PART TWENTY
PROJECT EVOLUTION
Design Response to Previous DRP and Council Comments

Design Response to Previous DRP and Council Comments
Scheme Development

THE HIDE

Land at Caldyne Park,
Turners Hill Rd,
West Sussex
RH10 4NB

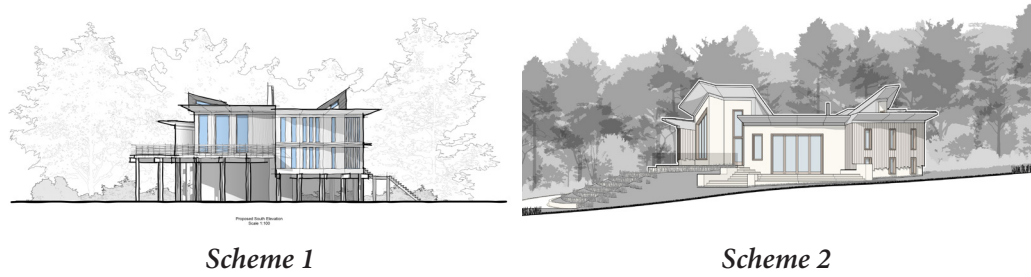
E - ‘The circular plan is handled as a series of faceted facades, rather than curved ones according to the floorplan but this is not revealed in the elevations which look flat.’

As part of the new drawing strategy, the floor plans were amended to show the building’s rectilinear structure clearly. However, in elevation, the building’s rectilinear elements are obscured by the dry-laid stonework and vertical timber cladding, which give the building the illusion of a curved facade. The proposal has been meticulously designed to ensure the harmony of the concentric concept is also embodied in the external form.

3.3 **Ecology Enhancement:**

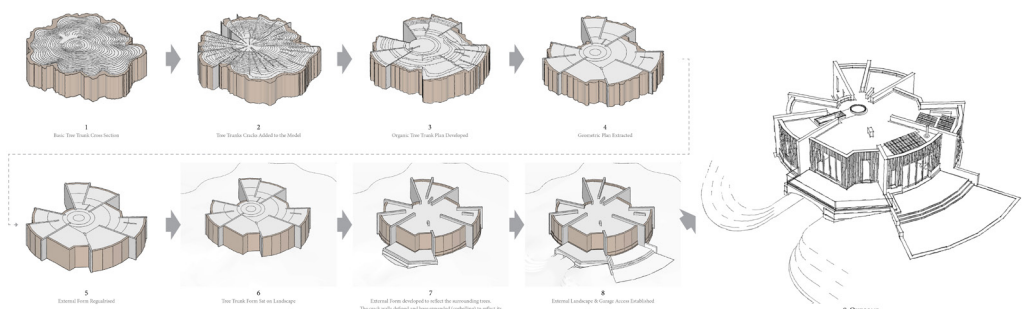
H - ‘There is limited information in the presentation demonstrating how the site would be enhanced. Whilst the proposal to remove invasive rhododendron is welcome, it is unclear how this would be achieved, over what period and the replanting proposals.’

The information regarding rhododendron removal and woodland management is clearly shown in Part 19 (paragraphs 4.0 - 4.27) of The Supporting Documents. Additional information on the rhododendron removal is also presented in parts 8, 9, and 18 of The Supporting Documents.

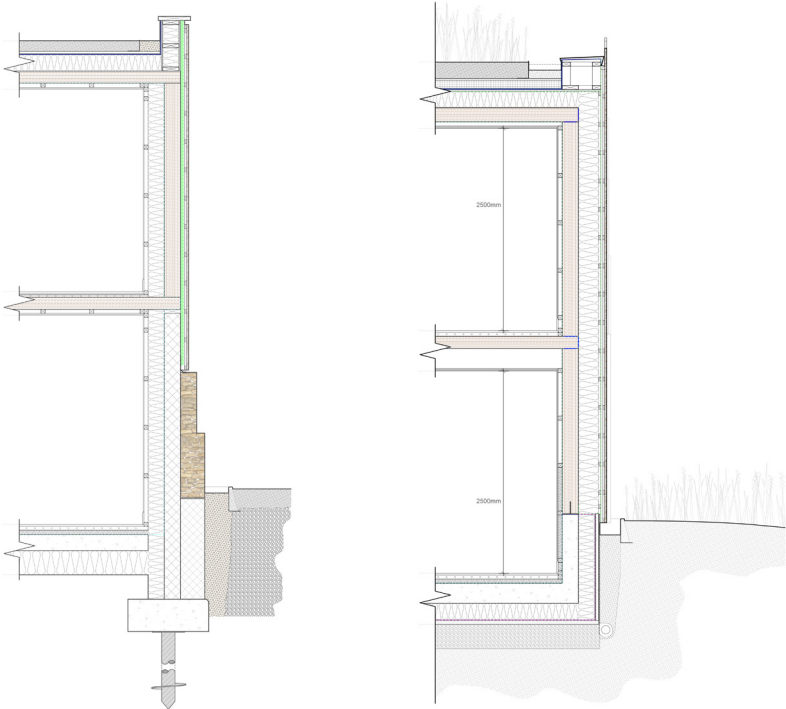
The plan provided also shows a raised timber walkway within the RPA of several trees and through the ancient woodland. I would need to see the installation methodology for this with the root protection areas of the trees affected.’

Since these comments, an arborist has been appointed, whom have undertaken an Arboricultural Report (including a Tree Survey, Tree Constraints Plan, Tree Retention & Protection Plan, and an Arboricultural Impact Assessment) and an Arboricultural Method Statement (which covers

the installation methodology for all landscaping/man made features within the RPA of trees, to note the timber walkway has since been removed from the scheme). This ensured that the proposed scheme has a minimal or no impact on the existing woodland trees and specifically addresses the tree officers’ comments.

4.6 Form, Appearance & Landscaping:

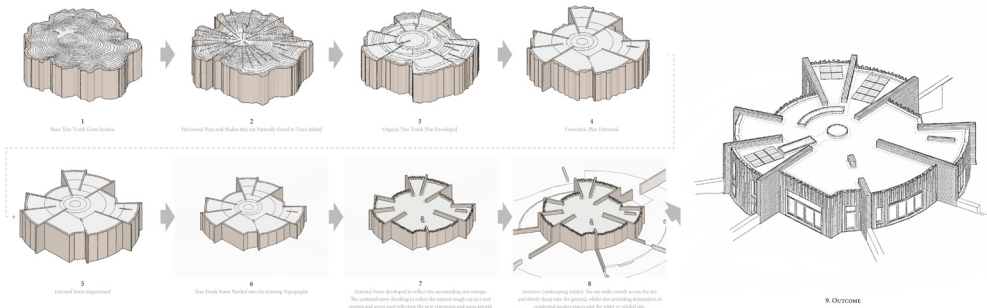
I - ‘The scheme as a whole is considered to be too urban and not organic enough. The choice of reclaimed bricks for the building does not relate to the concept, and the extent of potential hardstanding is excessive. The amount of wildflower area is unrealistic, so landscaping should be designed in greater detail.’

Since the feedback, we have reviewed everything from the start, refining the concept and ensuring that the form and appearance of the dwelling are harmonious with the site and reflect the core concept of a tree trunk. Throughout this development phase, we have extensively reflected on this core idea and refined the proposal’s design. As a result, we have created a dwelling form and appearance directly informed by this unique concept, resulting in a beautiful, exceptional building that is feasible to construct.

In addition to the changes in the floor plan (with all bedrooms moved to the north side), we have further developed the roof and the siting of the dwelling in the landscape, merging the building into its setting.

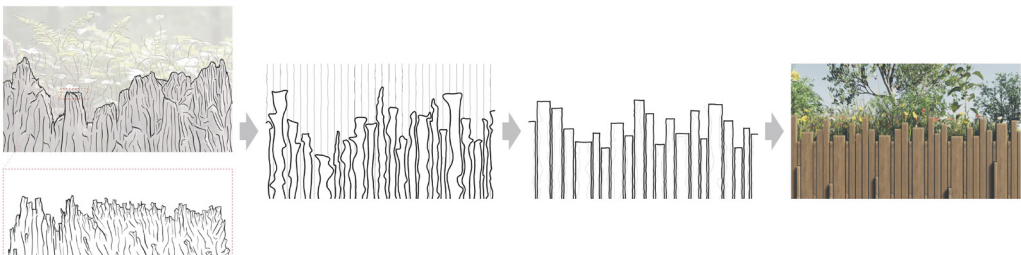
I - ‘...an opportunity has been missed to provide a triangular rooflight to reference why the building is the way it is, rather than the current shape which does not correspond.’

Upon reflection of this comment, we do not agree with the suggestion of a triangular rooflight for the following reasons:

1. A triangular rooflight in the centre of the dwelling conflicts with the overall design concept. While the perimeter of the dwelling features triangulated faces (32 sides), as one moves closer to the centre, the sizes of these faces become negligible and transition into a curve. This is evident in the kitchen, where the wall has been finished as a curved surface.

2. Furthermore, there are currently no Passivhaus-certified or suitable triangular rooflights available due to issues related to airtightness and thermal bridging.

Therefore, to fully adhere to the core concept whilst also ensuring buildability and compliance with Passivhaus standards, we have not proposed a triangulated rooflight.

4.10 Internal Experience:

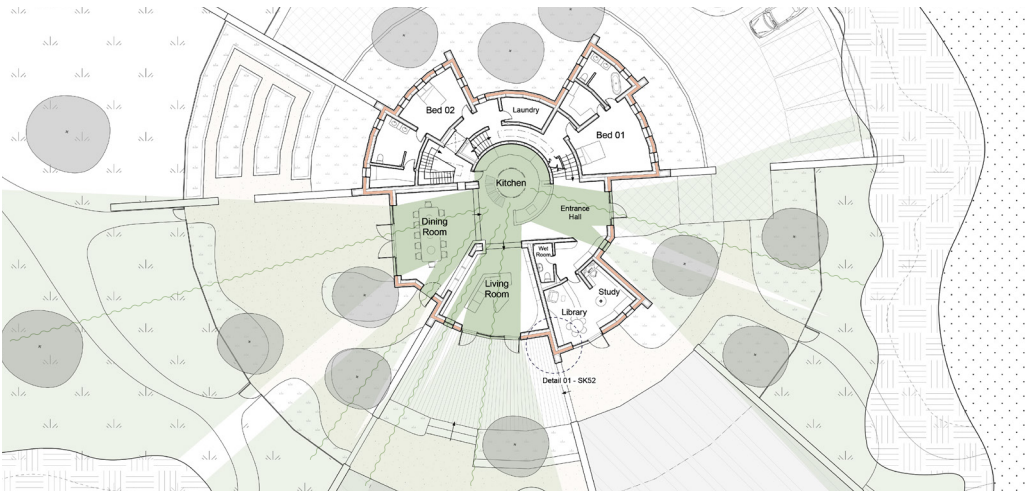
I - ‘The internal experience has not been fully understood, such that the kitchen will have a poor outlook being located in the centre..’

The kitchen serves as the central “hearth” of the dwelling, as is common in many homes. However, being the centre doesn’t mean it has a poor outlook. We have specifically designed the layout to maximise views from the kitchen. As you can see from the internal visualisations (please see section 14, pg 74 of the support documents), the kitchen boasts almost a 180-degree view, with large expanses of windows in the entrance, dining room, and living room, along with a sizable rooflight that lets natural light fill the kitchen.

These openings provide stunning views across the pond into the southern meadow, as well as from the outdoor dining area into the western meadow and traditional orchard. Additionally, views extend across the entrance area into the eastern garden. The rooflight offers a generous view of the sky above.
